**Economic Commission for Europe**

Retrofit Emission Control devices (REC)

**Draft new Regulation on uniform requirements for Retrofit Emission Control devices (REC) for heavy duty vehicles, agricultural tractors and non-road mobile machinery (NRMM) equipped with Compression Ignition engines, type approved according to Regulation No. 49 and NRMM and tractors with engines type approved according to Regulation No. 96.**

Draft Version 2 dated 11.08.2011

Figure 1.1:

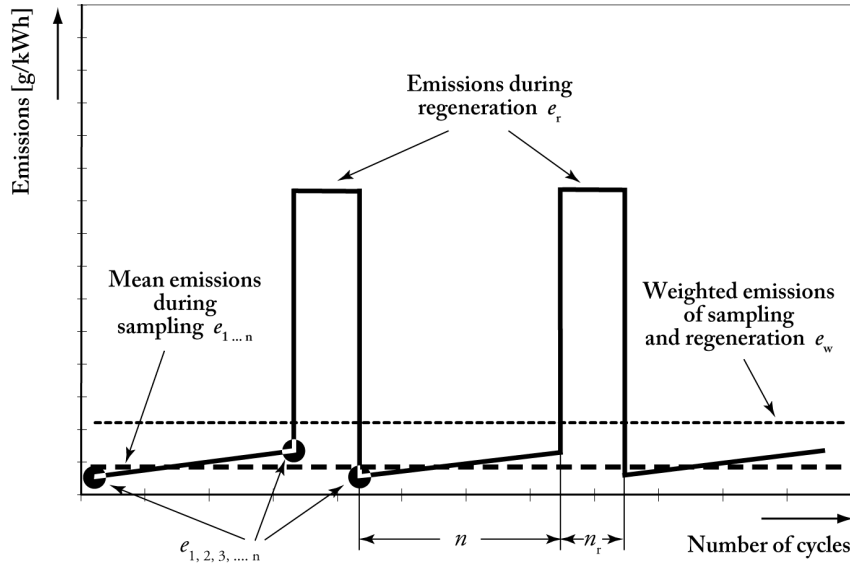
**Comment [S35]:** Sequence ought to mirror that in the flowchart

**Comment [JM36]:** Is order correct? Should regen factor, for instance, be determined before reduction level? Is the reference in the flowchart supposed to be to the declared reduction level?

**Comment [S37]:** Is the reference in the flowchart supposed to be to the declared reduction level?

**Comment [JM40]:** Is every 5<sup>th</sup> cycle enough? Couldn't a system regenerate and reload within that period?
